PLANNING BOARD AGENDA

**MAY 11, 2026
REGULAR MEETING**

**Re: Zoning Board Application
1817 Pine Terrace
Block 15, Lot 8
Our File LCPB 26-02**

**Re: Completeness Review #2
Tonero Variance Application
1817 Pine Terrace
Block 15, Lot 8
H2M Project No. LKCP2510**

FRONT ELEVATION
SCALE 1/4" = 1'-0"

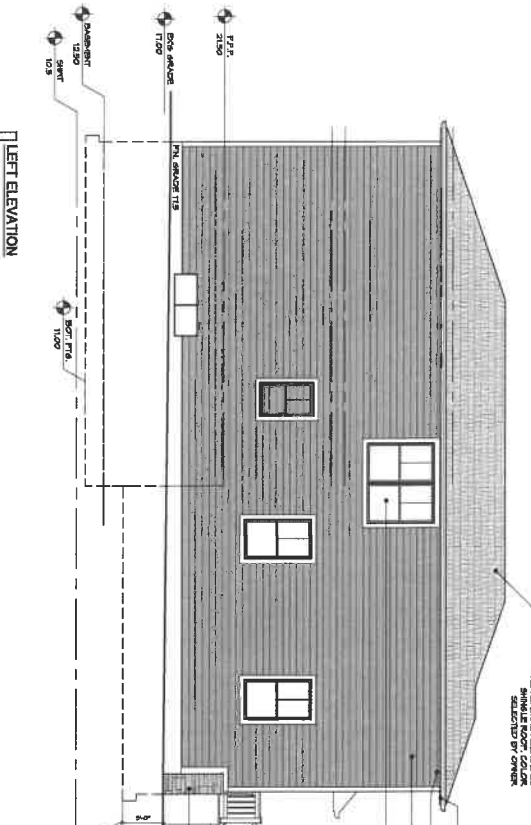
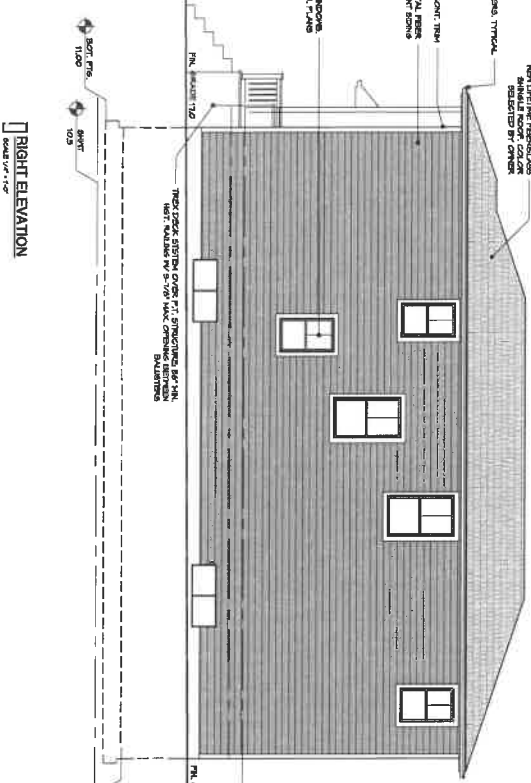
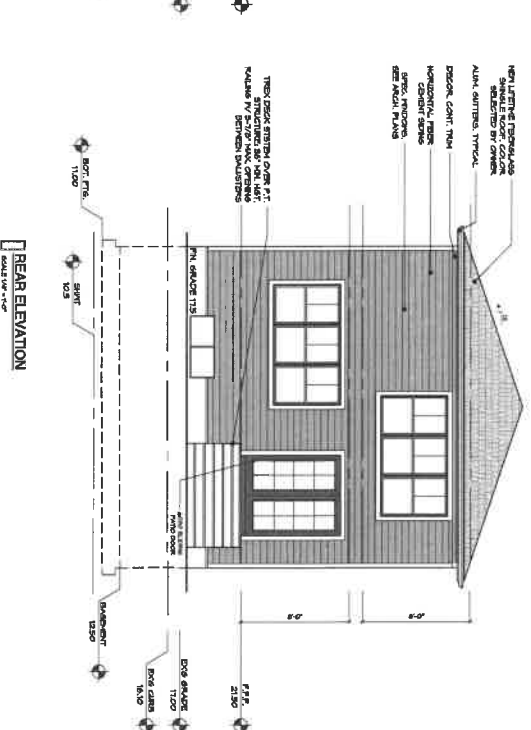
- The Architectural Plans do not depict the depth of the proposed dwelling's foundation on the elevation drawings. The Architectural Plans must be revised to show the depth of the foundation on the elevation drawings. Furthermore, the elevation drawings must depict the Seasonal High-Water Table (SHWT) as determined on-site and must achieve the 2 foot separation from SHWT to basement floor in accordance with Borough Ordinance 2024-1.

OVERALL DEVELOPMENT PLAN
 FOR
TAX BLOCK 36
TAX LOTS 25 & 26
 DIVISION OF LAND CONSTRUCTION
 HENRY COUNTY, MISSOURI

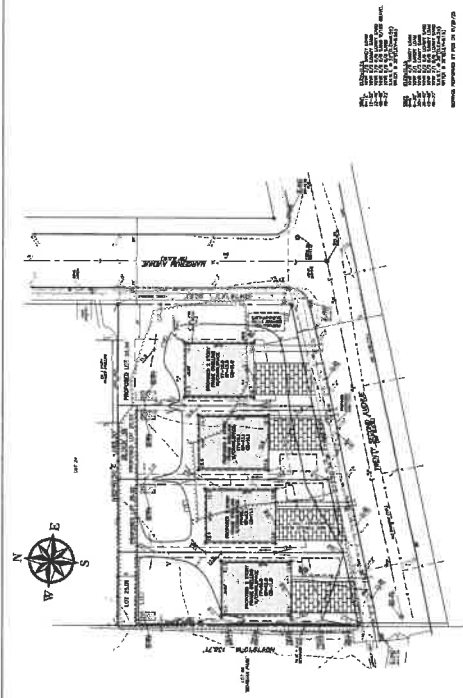
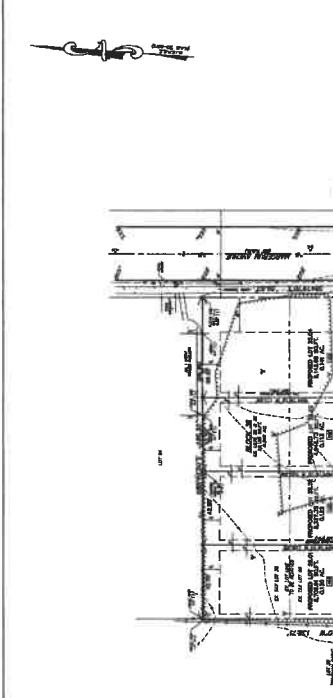
5. The application does not include Architectural Plans as part of the application. Each of the dwellings proposed on their respective lot appear to be approximations of the dwelling that will ultimately be constructed. The Board should consider requiring Architectural Plans to ensure that the dwellings will conform to the placeholder established on the Overall Development Plan. This suggestion is in keeping with the Major Development concerns cited in Item 1 above.

6. The space located at the curb between the two easternmost proposed lots is approximately 14ft, which isn't long enough for a true parking space. There is abundant space along the proposed subdivision to maximize the number of street parking spaces, given the Borough's ongoing struggle with street parking. The layout of driveways should be revised to eliminate partial spaces to the extent possible.

9. The application package includes a Sketch Plat for the proposed major subdivision; however, while this document suffices for the Board's consideration with respect to the proposed subdivision, it does not rise to the level of detail necessary for perfecting the subdivision vis map filing. Accordingly, I have not reviewed this document for conformance with Title Recordation Act requirements and reserve the right to such review when a proper Final Subdivision Plat is provided to the Board.
